KITCHEN/WARDROBE ROOM S-O FASCIA

| <b>NEWMAR CORP</b><br>P.O. Box 30,<br>Nappanee, IN. 46550<br><br>UNITS: INCHES<br>TITLE BLOCK: 80D | Model: | SSCC 3731 | Sheet  | 1 OF 3                       | Drawn by: | R. W.   | Checked by: | E. C.  | Revision: CHANGED VERTICAL FASCIA TO NEW STYLE AND CHANGED HEIGHT TO SHOW 70-7/8" ON        | By: S. M.       |

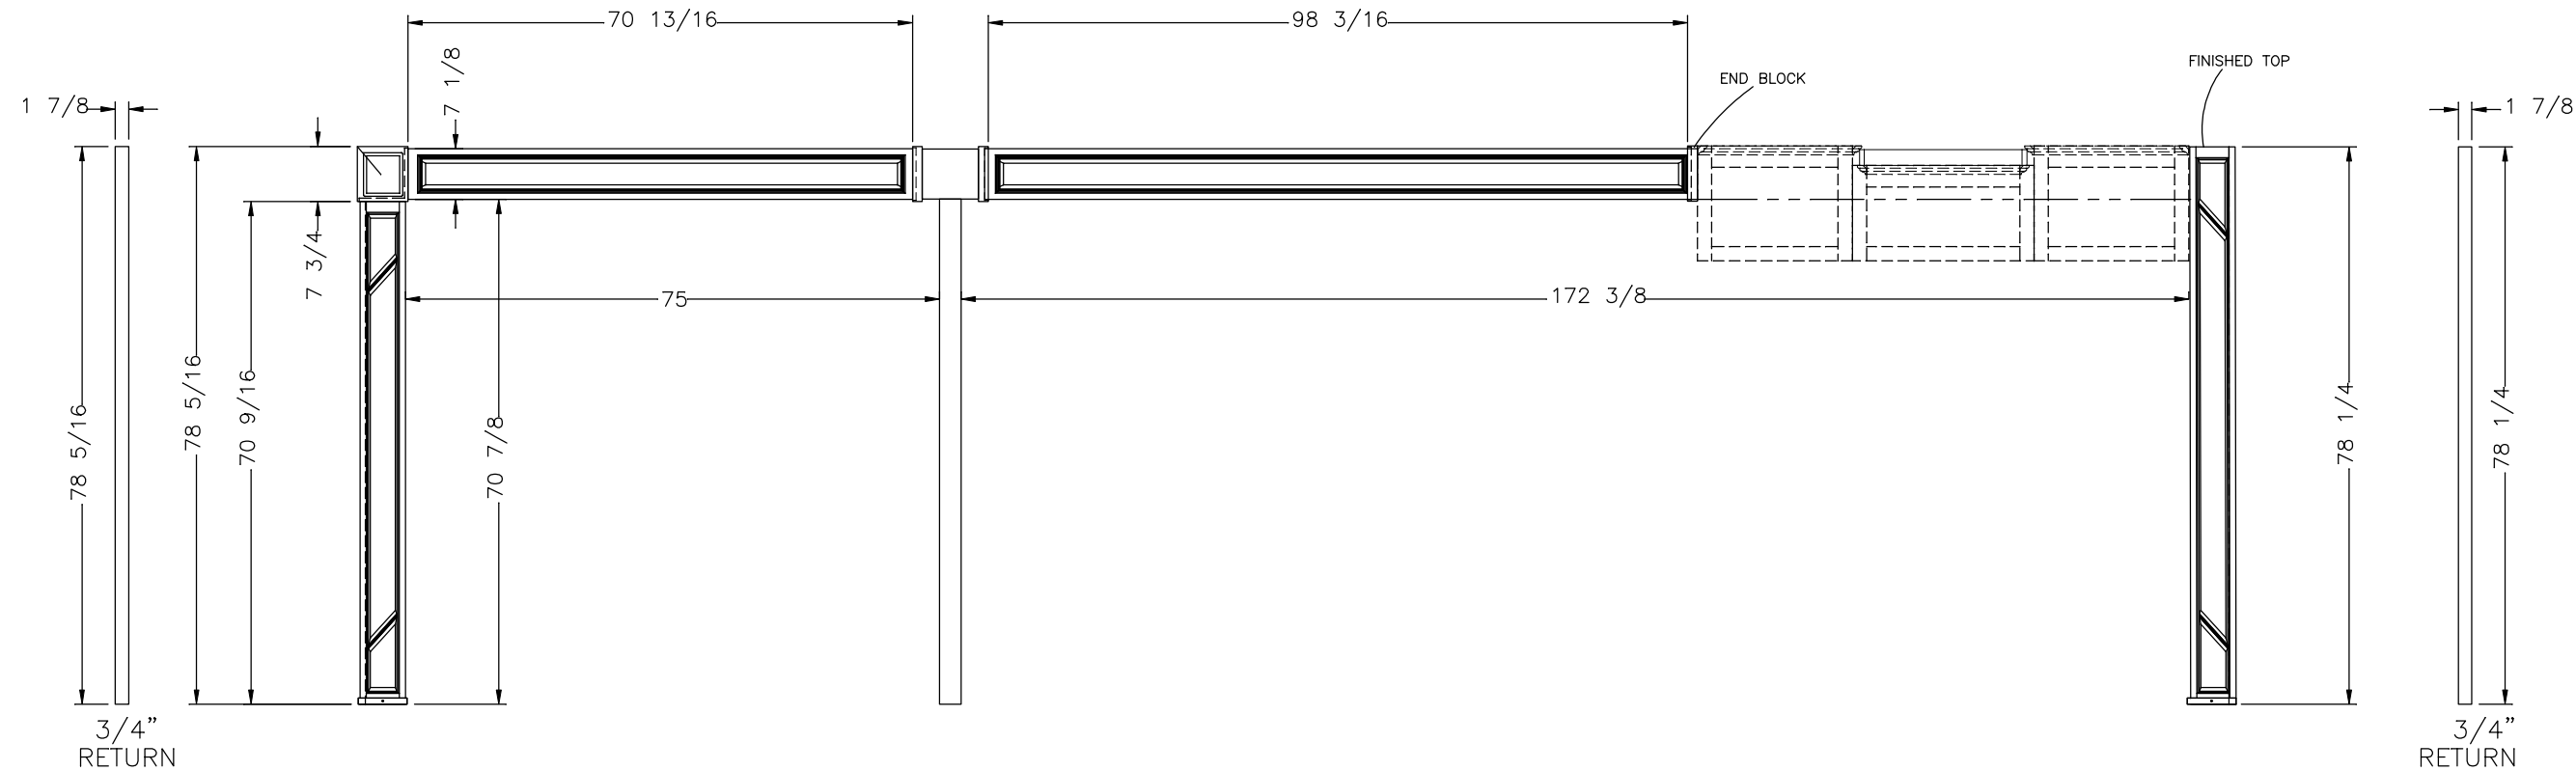
|                                                                                                    | Title: | FASCIA    | I.D. # | 2024\CC\CAB\FASCIA\SSCC_3731 | Date:     | 8/30/22 | Date:       | 9/8/22 | NO PRINT LAYER FROM BOTTOM OF VERTICAL FASCIA TO BOTTOM OF HORIZIONAL FASCIA (2024 ECO #88) | Date:EC 4/11/23 |
|                                                                                                    |        |           |        |                              |           |         |             |        | Revision: REPLACED BOTTOM TRIM ON VERTICAL FASCIA WITH NEW TRIM THAT IS                     | By: S. M.       |
|                                                                                                    |        |           |        |                              |           |         |             |        | 7/8"H ILO 1/2". ALSO ADDED ADDITIONAL DIMENSIONING TO MATCH VT PRINTS (PCR #240447)         | Date:EC 1/27/23 |
